UNITED STATES PATENT AND TRADEMARK OFFICE

APPLICATION NO.	FILING DATE	FIRST NAMED INVENTOR	ATTORNEY DOCKET NO.	CONFIRMATION NO.
10/803,085	03/18/2004	Checrallah Kachouh	740116-511	4165
22204	7590	10/20/2005	EXAMINER	
NIXON PEABODY, LLP 401 9TH STREET, NW SUITE 900 WASHINGTON, DC 20004-2128			LUGO, CARLOS	
			ART UNIT	PAPER NUMBER
			3676

Office Action Summary	Application No.	Applicant(s)
	10/803,085	KACHOUH, CHECRALLAH
	Examiner Carlos Lugo	Art Unit 3676

DETAILED ACTION

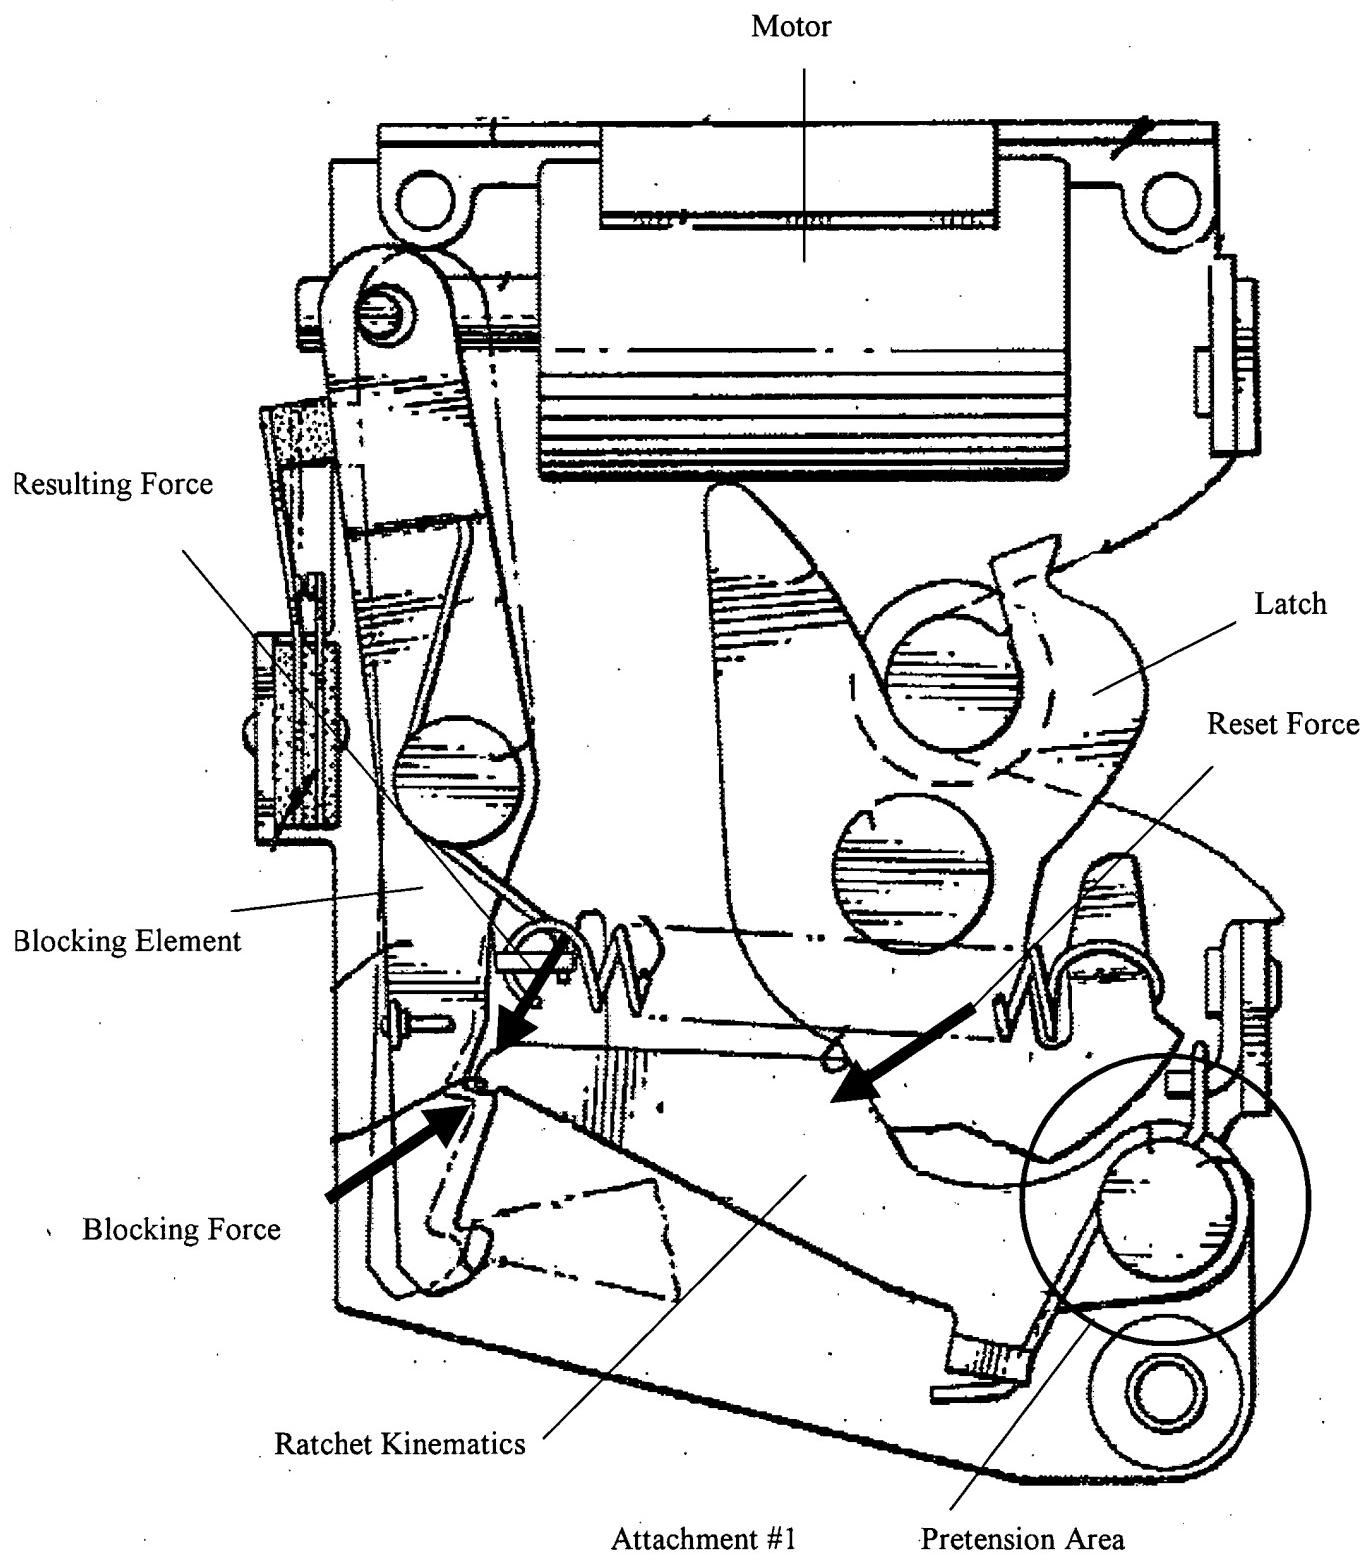
As to claim 2, Johnstone '761 illustrates that the ratchet kinematics (34) further comprises a step-down gearing, i.e., the amount of reset force which acts on the ratchet kinematics (34) by the latch (28) is greater than the resulting force acting on the blocking element (46) from the ratchet kinematics (see attachment #1). The step-

As to claims 14 and 15, Johnstone '761 illustrates that the transmission lever is pretensioned and wherein the blocking force of the blocking element opposes the pretensioning of the transmission lever (see attachment #1).

Attachment #2

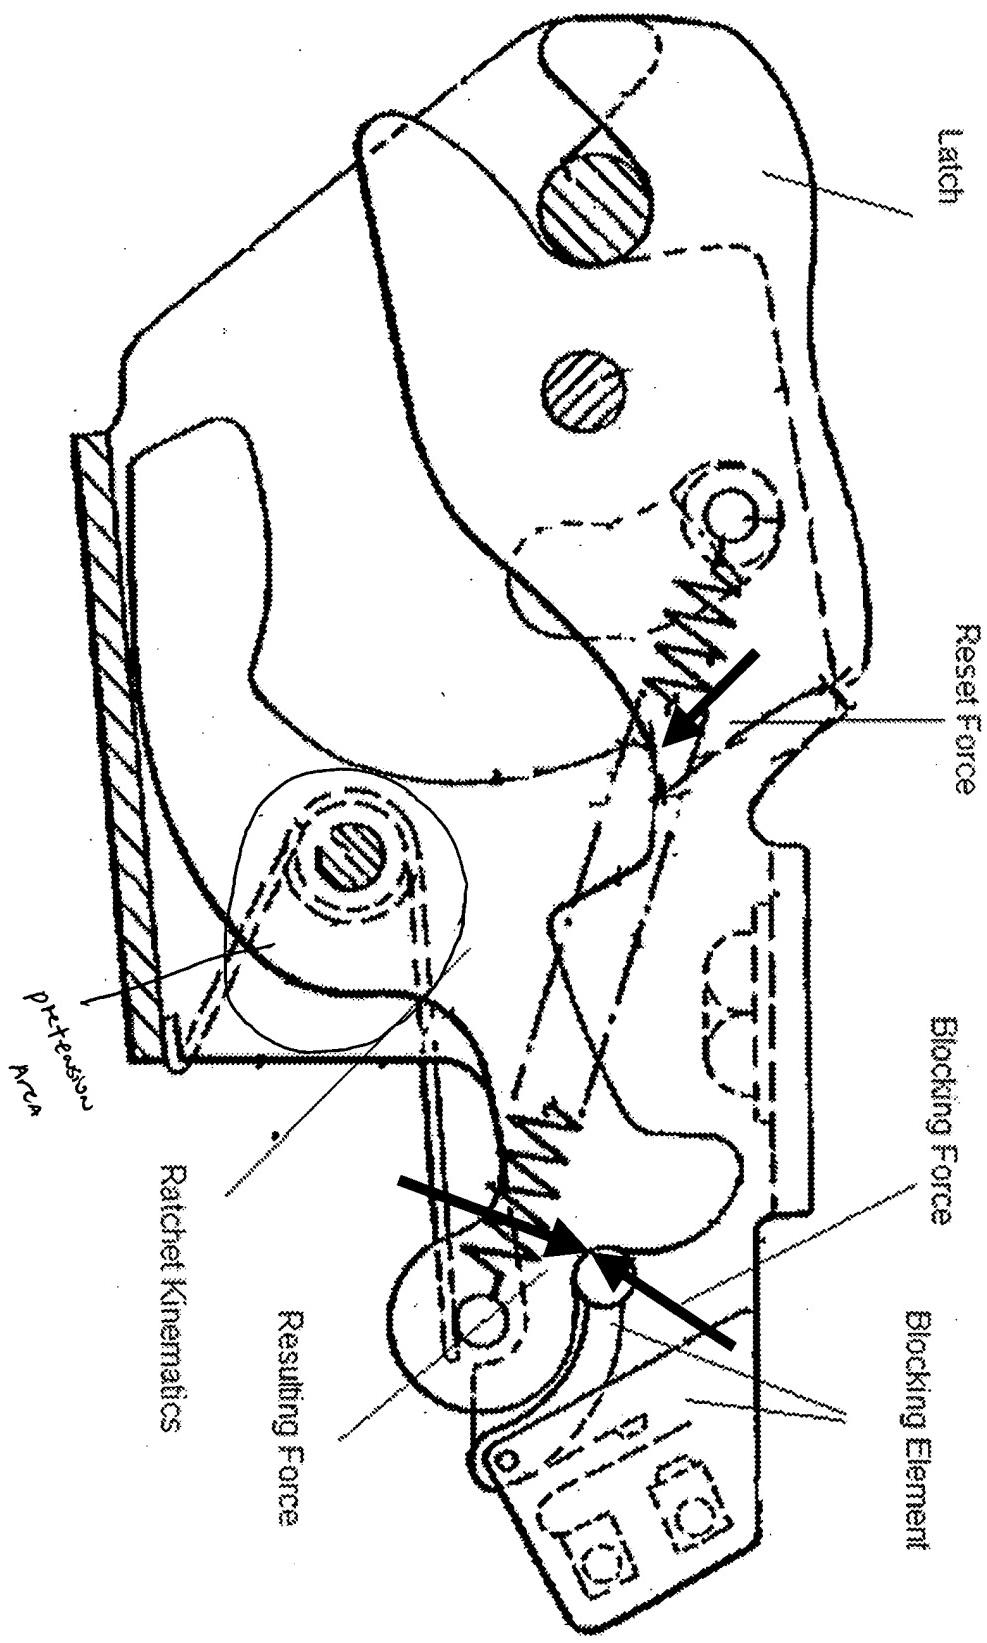
As to claim 2, Raffelsiefer illustrates that the ratchet kinematics (5') further comprises a step-down gearing, i.e., the amount of reset force that acts on the ratchet kinematics (5') by the latch (4') is greater than the resulting force acting on the blocking element (8' and 13') from the ratchet kinematics (see attachment #2). The step-down gearing reduces a blocking force applied by the blocking element to block the latch (when the blocking element is moved, the force that the latch 4' exerts on the ratchet kinematics 5' reduces to zero the blocking force).

As to claims 14 and 15, Raffelsiefer illustrates that the transmission lever is pretensioned and wherein the blocking force of the blocking element opposes the pretensioning of the transmission lever (see attachment #2).
